IMPACT IMPLEMENTATION REPORT (IIR)

| Issue Number | IN012/17 | | |
| Short Description of change(s) | Remove requirement to provide a meter read with a MIRN Status Update for Deregistered transactions in SA (Industry Harmonisation) | | |

IMPACT & IMPLEMENTATION REPORT

PF(B2M) – R6.1: Permanent Removal (South Australia)

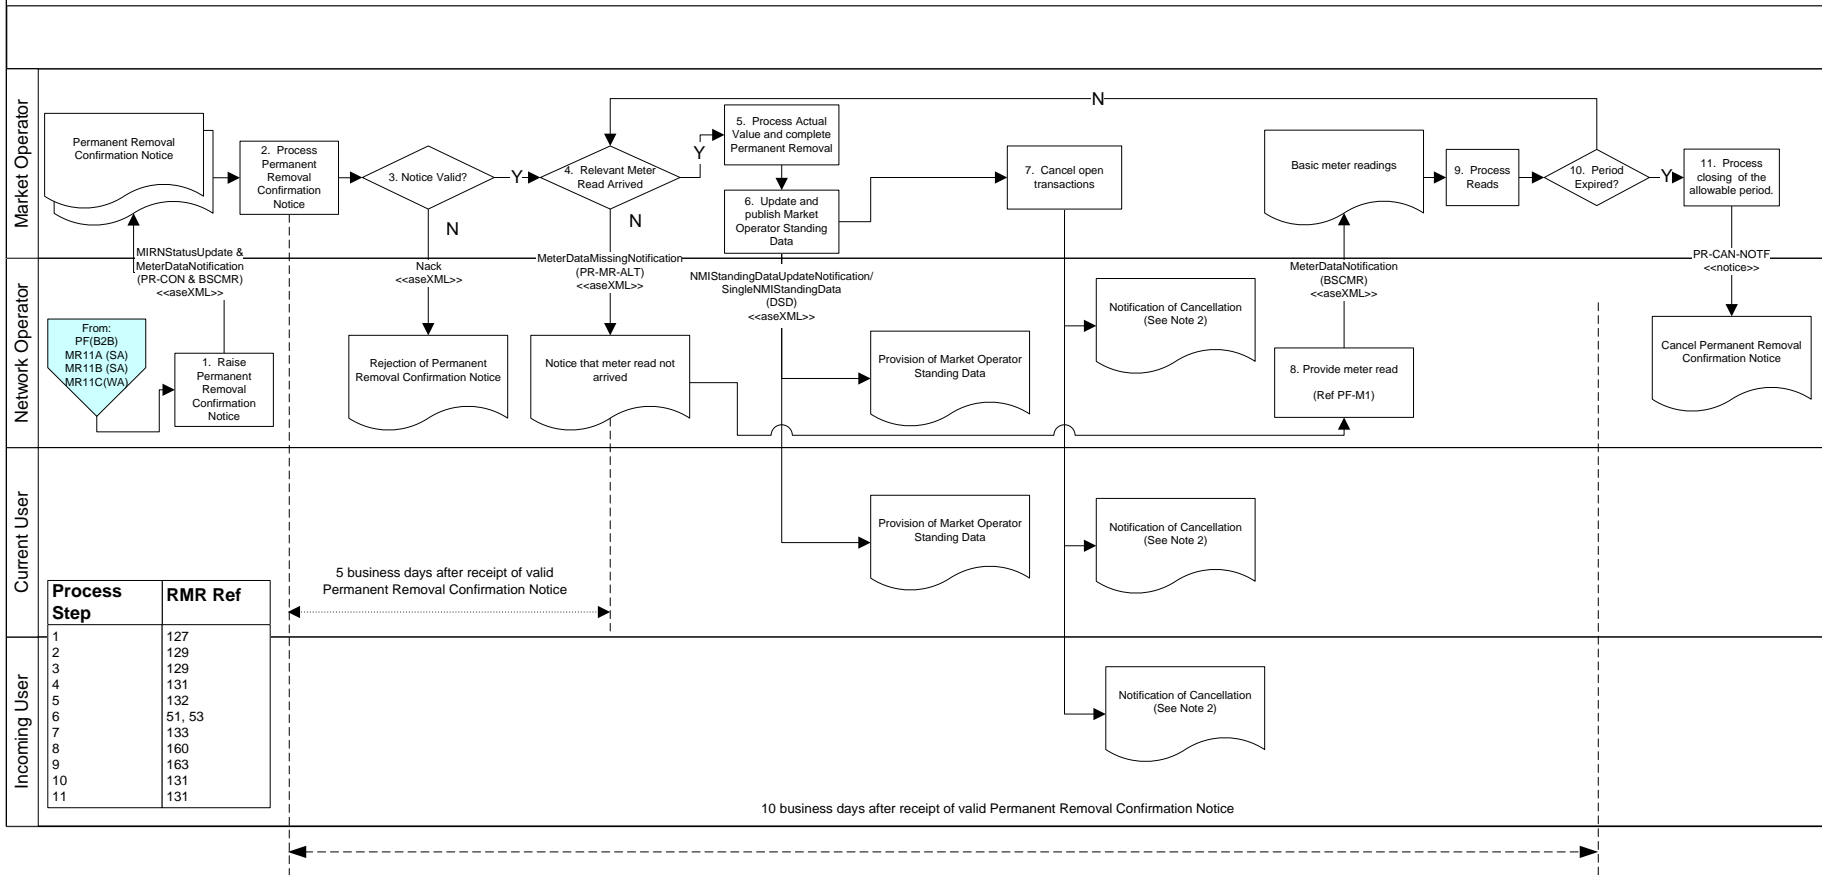
- Does not include meter read validation process.
- Network Operator's internal process to ensure a final meter read is provided to AEMO and User if not already provided
- Future AEMO system change to ensure deregistration only allowed **after** decommission
- Cancellation types:
 - CATSNotification(CANCELLED); TFR-CAN-NOTF; aseXML;
 - CATSNotification(CANCELLED); ECNET-CAN-NOTF; aseXML;

| Ref # | Company | Clause # | Issue / Comment | Proposed text Red strikeout means delete and <u>blue underline</u> means insert | AEMO Response (AEMO only) |
|-------|----------|----------------|---|---|--|
| 1 | APA | PF(B2M) – R6.1 | <p>Re-number process flow steps as suggested in embedded diagram to align Incoming User Process Step/RMR Ref table in diagram (last swim lane) to keep consistent with previous SA and new WA process flow diagrams.</p> <p>Consider adding a Notes section on bottom of page as indicated on embedded diagram.</p> |  PF(B2M) R6.1 20190503.pdf | AEMO acknowledges APA's feedback and has amended the process flow PF(B2M) – R6.1 and sequence diagram SD(B2M) – R11 as per APA's suggestion since it adds further clarity. |

PF(B2M) - R6: Permanent Removal (MIRN Deregistered)(Basic metered site)

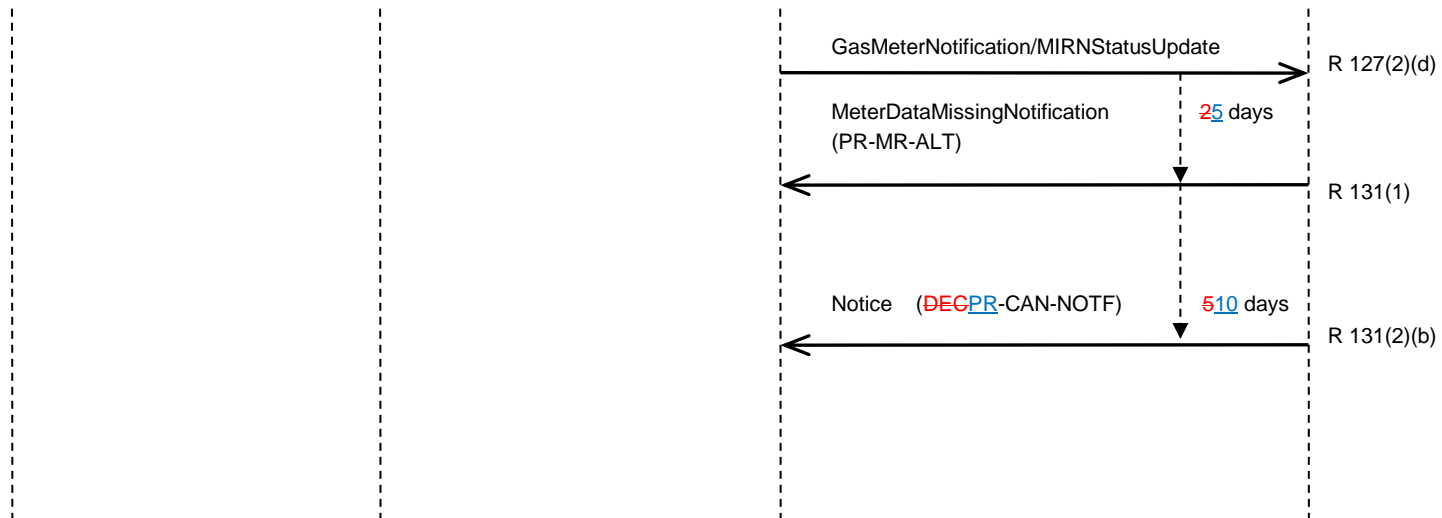
- Create a new SA version of the process flow 'PF(B2M) – R6: Permanent Removal (MIRN Deregistered) (Basic metered site)' by removing the process steps related to availability of meter read and redundant 'Notes' at the bottom of the diagram
- Indicate that the existing process flow mentioned above now applies to WA only
- Indicate the sequence diagram R11 now applies to WA only and amend the timings to bring them in line with the RMP SA
